Product Change Notification

Type of Notification: Safety standards and components change

PCA600F-□、PCA600F-□-T、PCA600F-□-P2、PCA600F-□-TP2

Fig. 2.2 Life expectancy of fan (Left : Current, Right : After Changed)

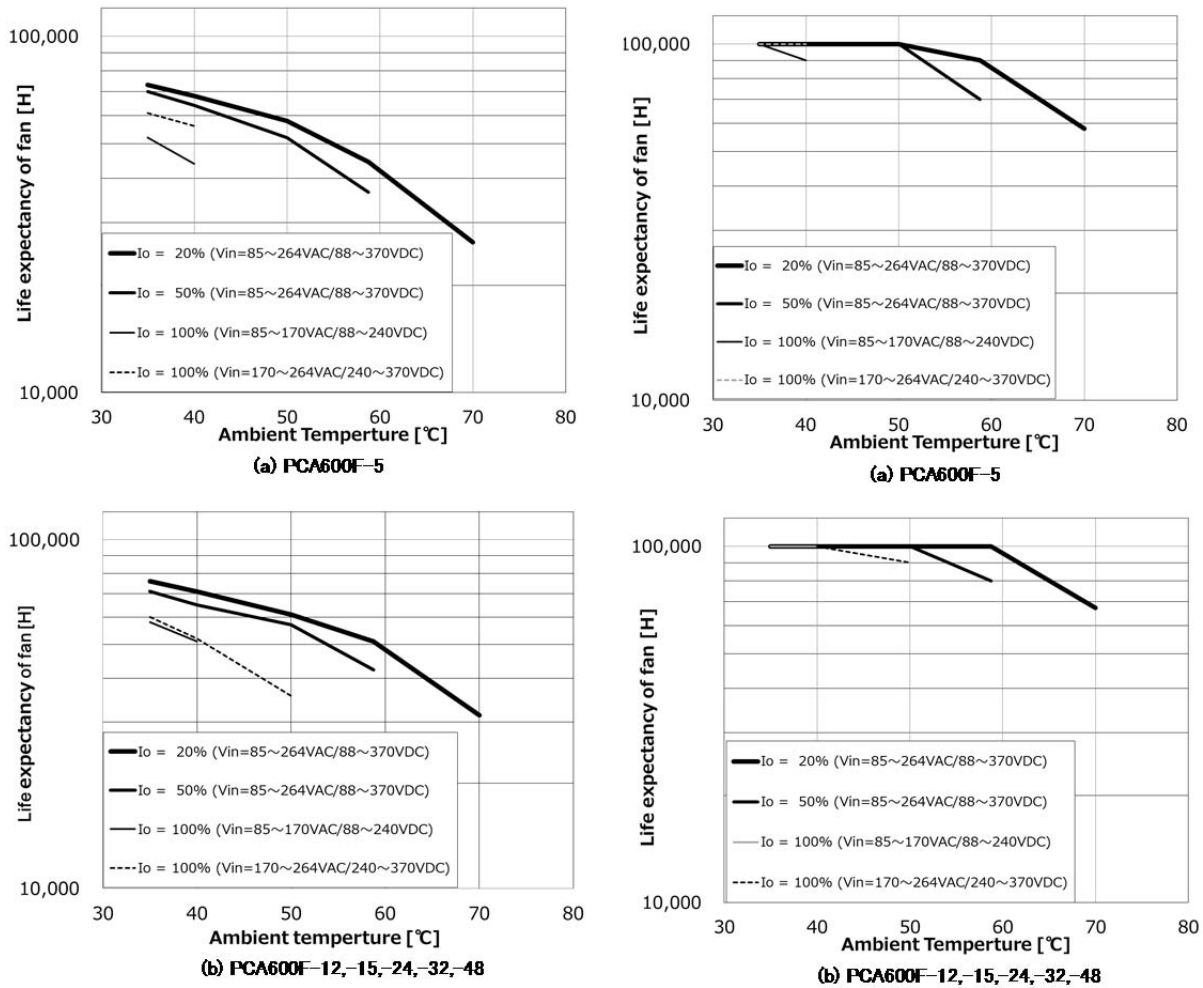
Fan (FAN801) will be changed because of improving procurement availability. Please see table 2.2 for details.

No.	Part Name	Current	After Change	Notes
1	Fan FAN801	9AG0412H6006 (SANYO DENKI)	04020VG12RBT01 (MinebeaMitsumi)	Refer to Fig. 2.1.

Life expectancy of fan will be improved. (Refer to Fig2.2.)
